STANDARD DEPARTURE CHART - INSTRUMENT

RJNH / HAMAMATSU

SAGRA FIVE DEPARTURE

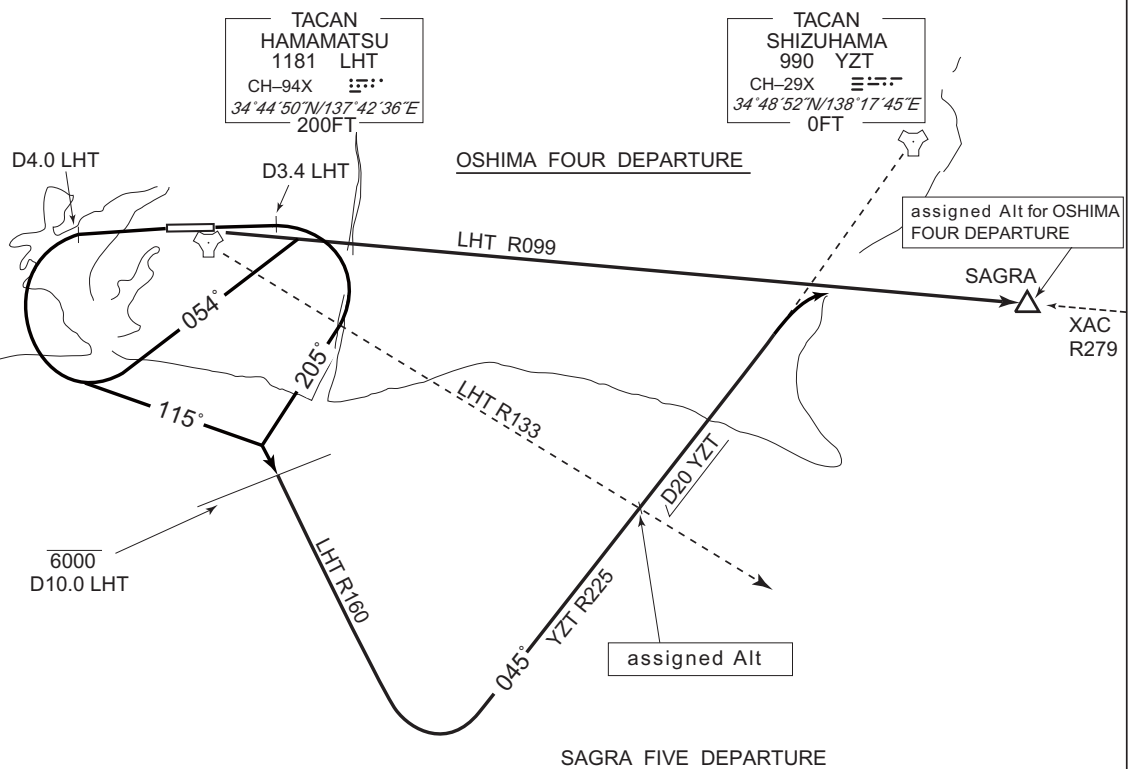
CHANGE : PROC name, PROC course(SAGRA FIVE DEPARTURE, OSHIMA FOUR DEPARTURE). Note deleted(SAGRA FIVE DEPARTURE, OSHIMA FOUR DEPARTURE).

ATSUMI FIVE DEPARTURE

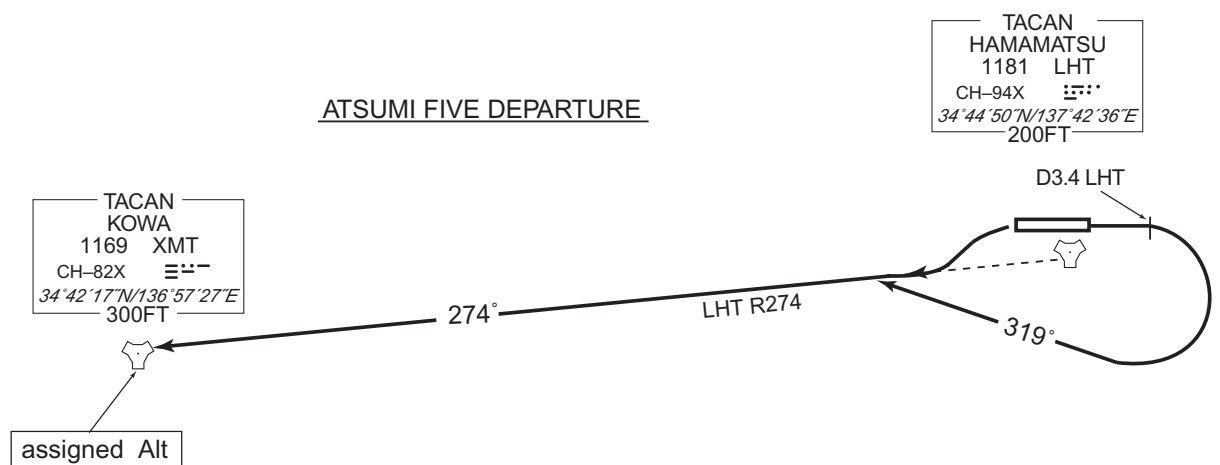
CHANGE : PROC renamed. PROC course. Note deleted.

HAMAMATSU REVERSAL THREE DEPARTURE

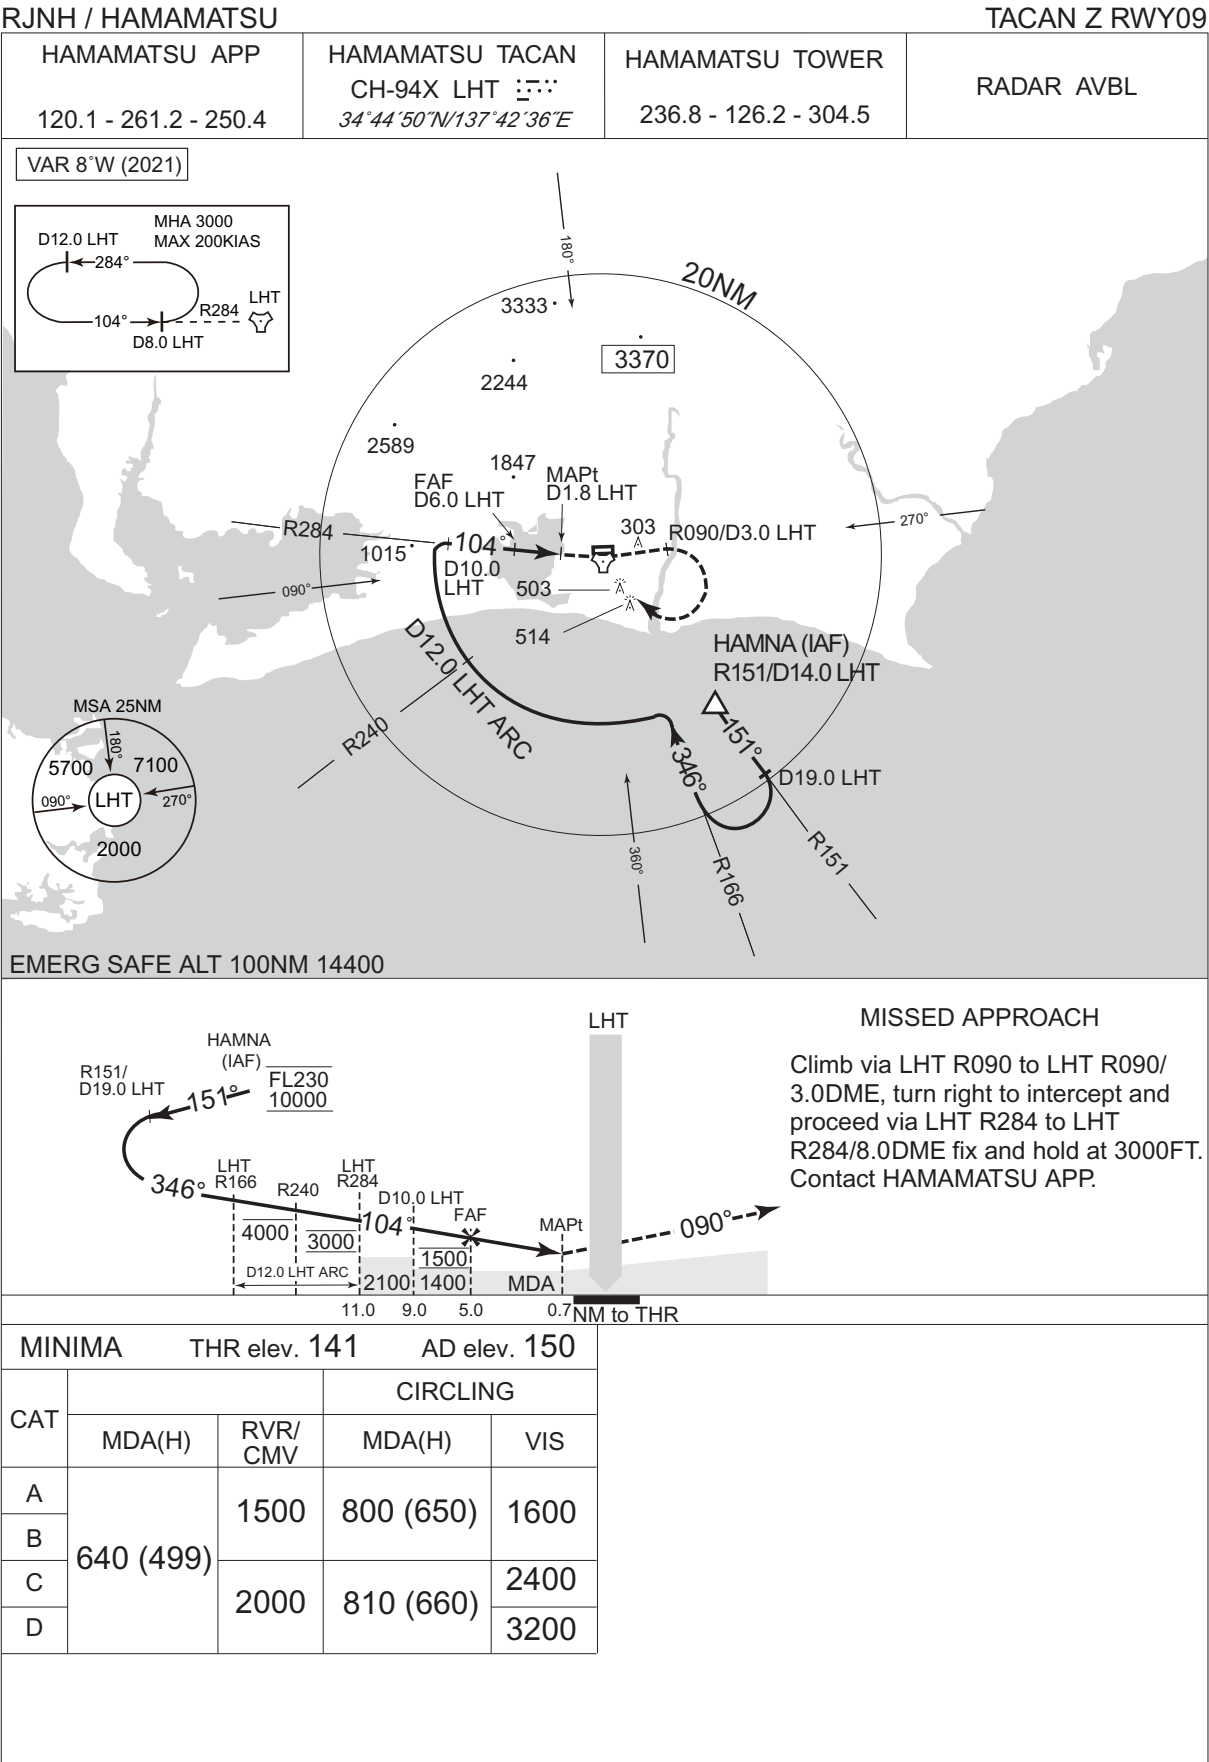
CHANGE : PROC renamed. PROC course. Note deleted.

TACAN Y RWY09

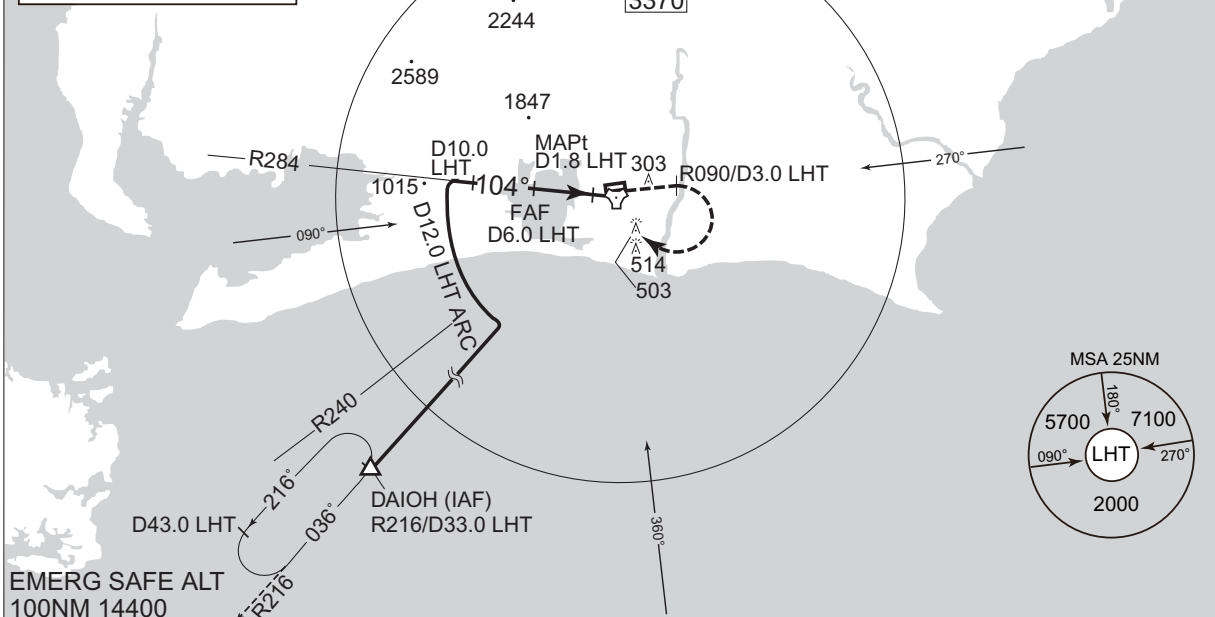
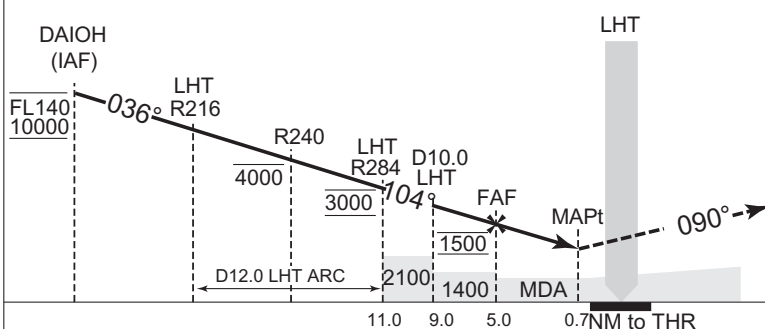
CHANGE : VAR. PROC renamed. PROC course. Description of FAF, MAPt added. OBST added(HGT 303).
OBST deleted(HGT 410, 504). MISSED APPROACH course. ALT restriction(DAIOH). OCA/H added. MDA(H) for CIRCLING.

INSTRUMENT APPROACH CHART

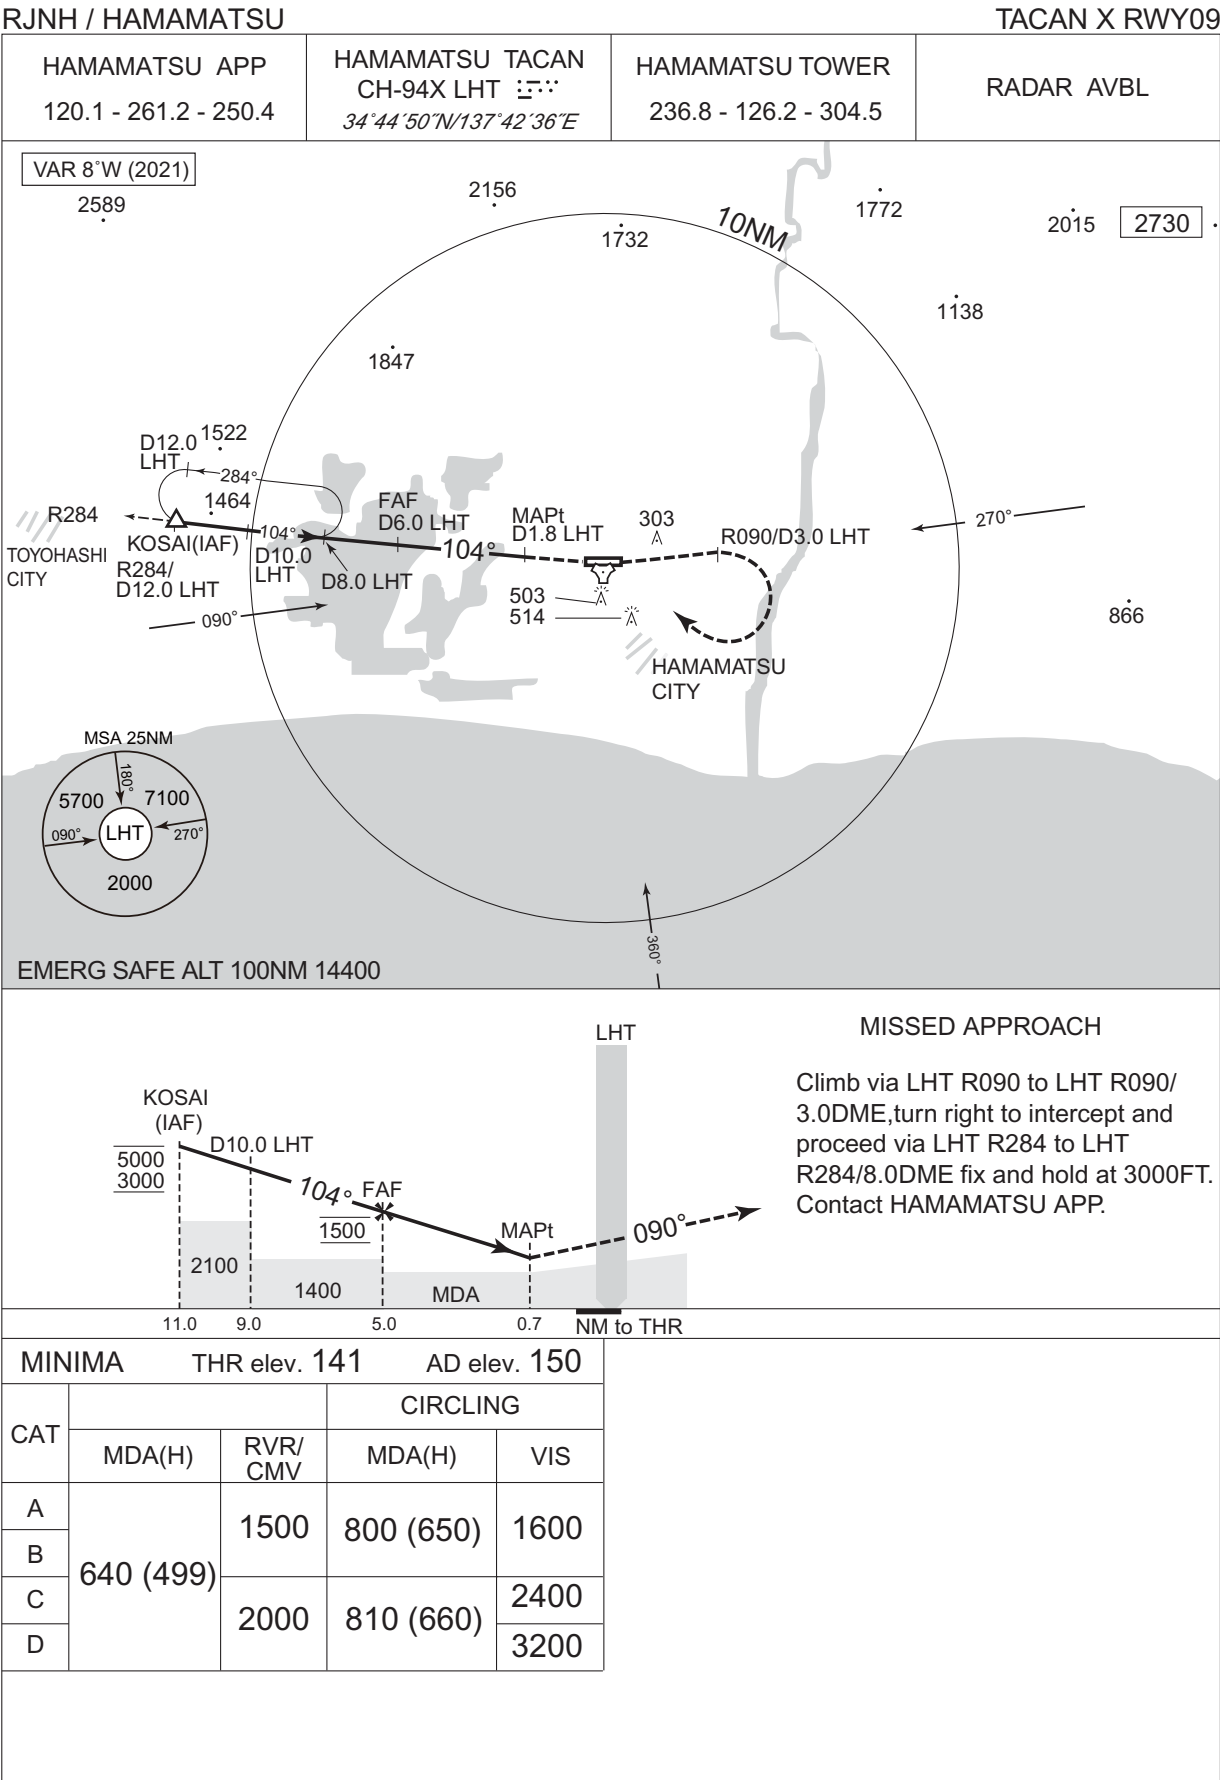
CHANGE : VAR. PROC renamed. PROC course. Description of FAF, MAPt added. MSA. OBST HGT(HGT 303).
OBST deleted(HGT 410, 504). MISSED APPROACH course. OCA/H added. MDA(H). MDA(H) for CIRCLING.

TACAN Z RWY27

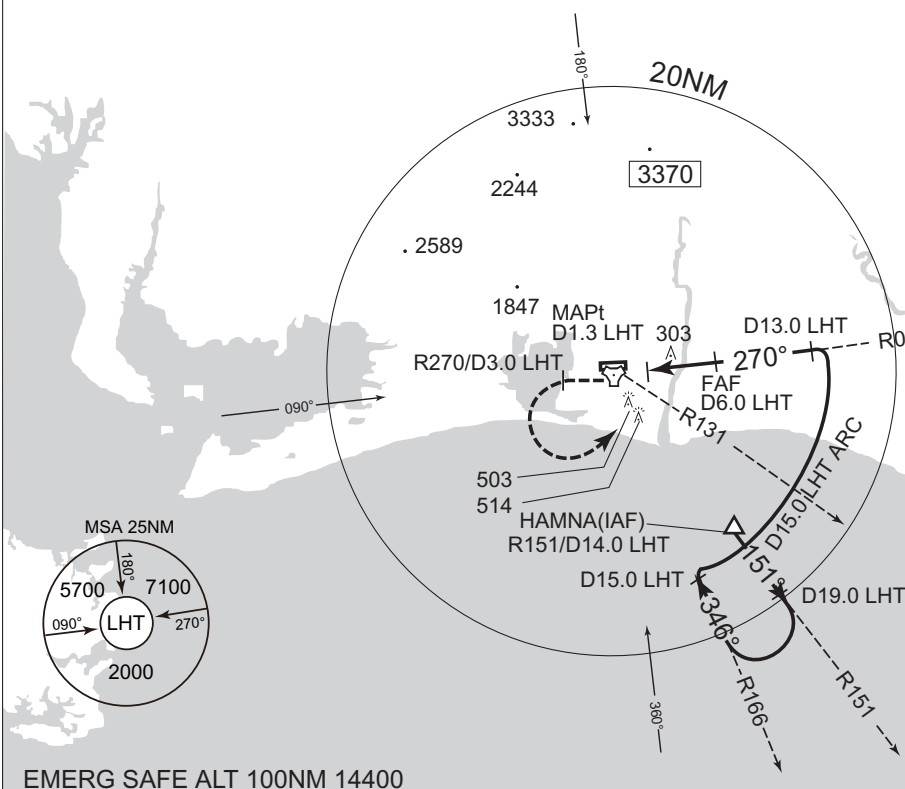
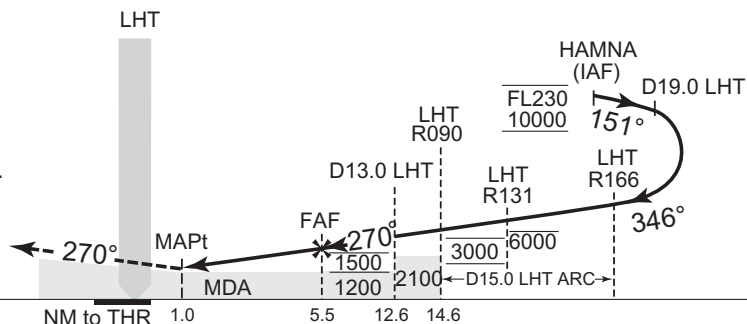
CHANGE : VAR. PROC renamed. PROC course. Description of FAF, MAPt added. OBST added(HGT 303).
OBST deleted(HGT 410, 504). MISSED APPROACH course. ALT restriction(LHT R090). OCA/H added. MDA(H). MDA(H) for CIRCLING.
